ISO 12215-5

Is below Right? if it's wrong, Please tell me why and how to do

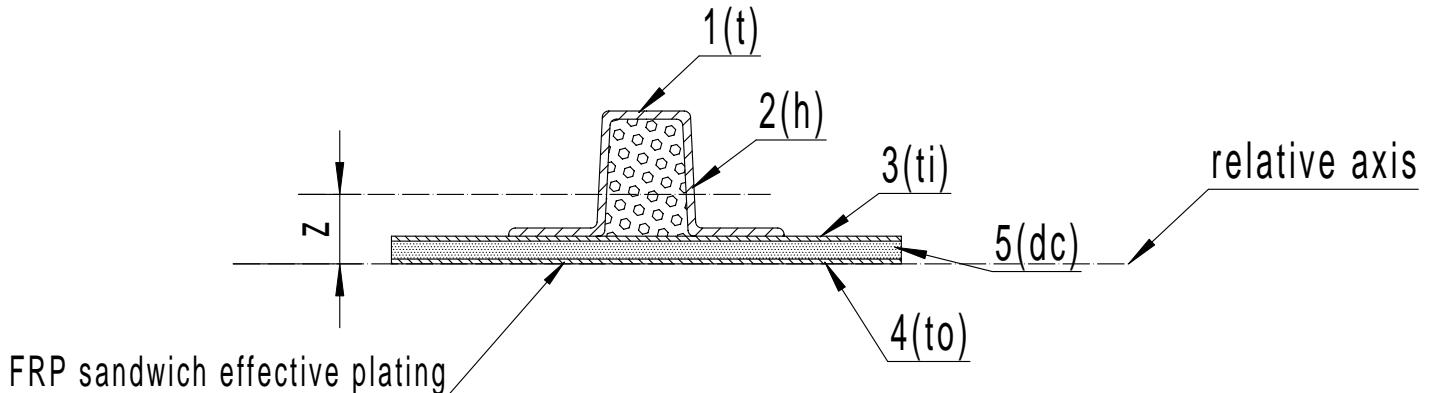
$$A = A_1 + A_2 + A_3 + A_4$$

$$i = i_1 + i_2 + i_3 + i_4$$

$$Ai^*zi = A_1^*(t/2+h+ti+dc+to)$$

$$Ai^*zi^2 = A_1^*(t/2+h+ti+dc+to)^2$$

$$+ A_2^*(h/2+ti+dc+to)$$

$$+ A_2^*(h/2+ti+dc+to)^2$$

$$+ A_3^*(ti/2+dc+to)$$

$$+ A_3^*(ti/2+dc+to)^2$$

$$+ A_4^*(to/2)$$

$$+ A_4^*(to/2)^2$$

$$z = Ai^*zi / A$$

$$I = Ai^*zi^2 + i - A^*z^2$$

$$SM = \text{Min}[I/z \text{ or } I/(t+h+ti+dc+to)]$$

Note: In calculation, no have  $A_5$  and  $i_5$  etc. the thickness of core only play the role in computing "z"
